SUBJECT: REVALIDATION OF THE MODEL NO. NCS-45 PACKAGE, GERMAN  
PACKAGE DESIGN CERTIFICATE NO. D/4347/B(U)F-96, REV. 0

SAFETY EVALUATION REPORT  
Docket No. 71-3084  
Model No. NCS 45 Package  
German Package Design Certificate No. D/4347/B(U)F-96  
Revision 0

Figure 1 – Containment Boundary for NCS 45

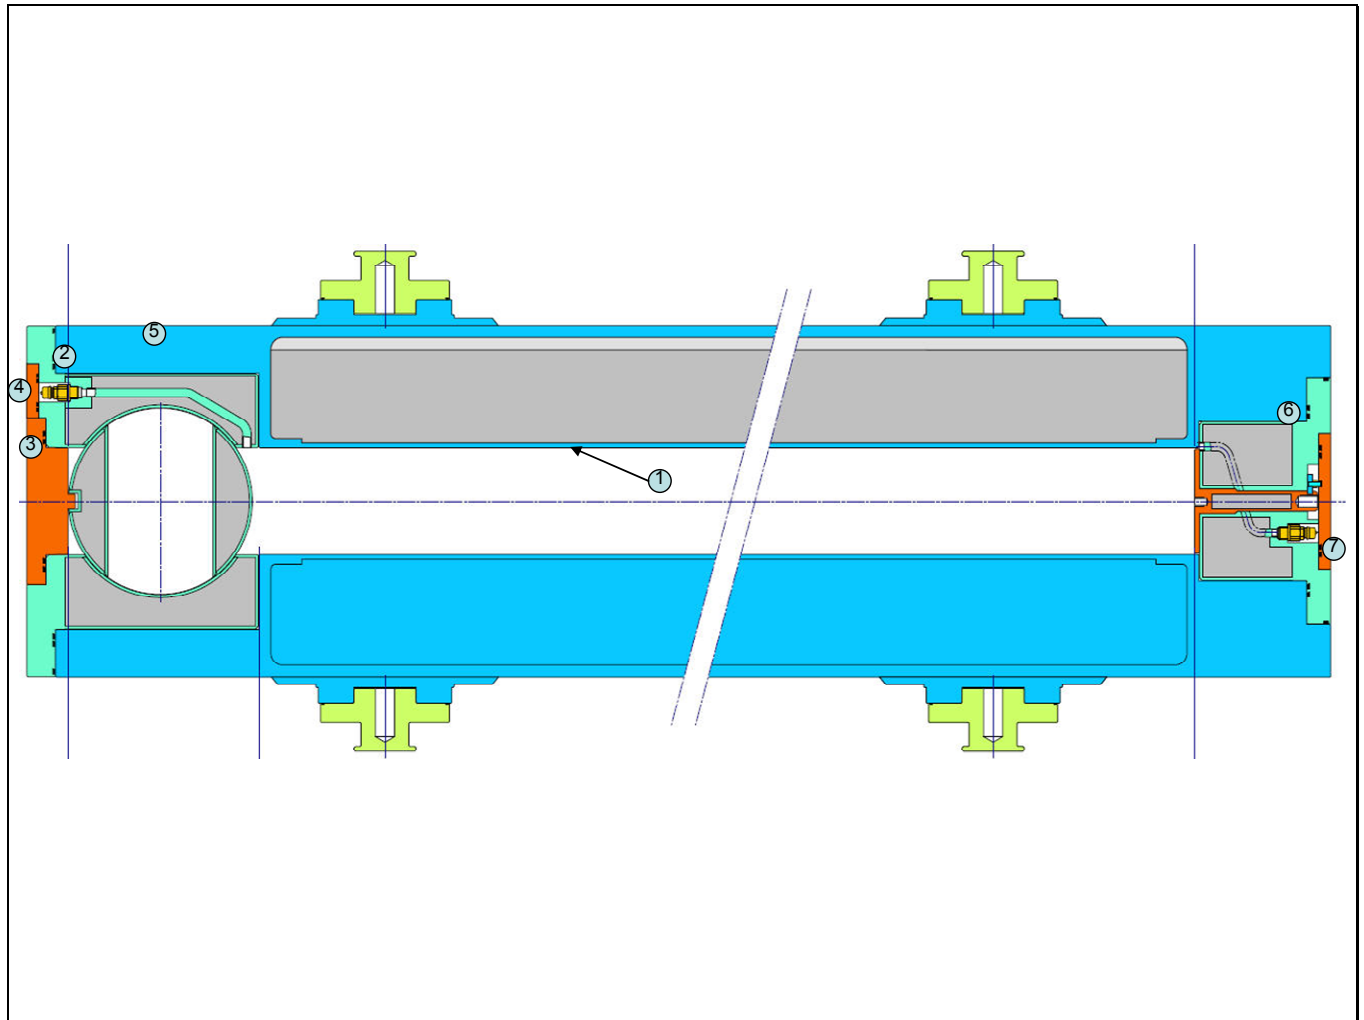
The containment system of the NCS 45 is described in Section 3.10 of report NCS 0017, Rev. 3, and is made up of the components listed below, which are numbered to correspond to the locations in Figure 1.

- The inner tube (vessel), including the head piece and foot piece of the packaging main body and the connecting welds (1)
- The flange of the top lid plug with associated inner seal and bolts (2)
- The rotary lock lid with associated inner seal and bolts (3)

- 
- The coupling lid with associated inner seal and bolts (4)
- The rotary lock driving lid with associated inner seal and bolts (5)
- The flange of the bottom lid with associated inner seal and bolts (6)
- The discharge lid plug with associated inner seal and bolts (7)

Note that item 5 above is not explicitly shown in Figure 1 (but can be viewed in Drawing # 0-150-151-03-00), so the approximate location of this component is provided:

The acceptance criteria are in accordance with the requirements of IAEA TS-R-1, paragraph 502. The staff recommends these leak testing limits and leak testing procedure (PA-02-06) be required for shipments in the U.S.
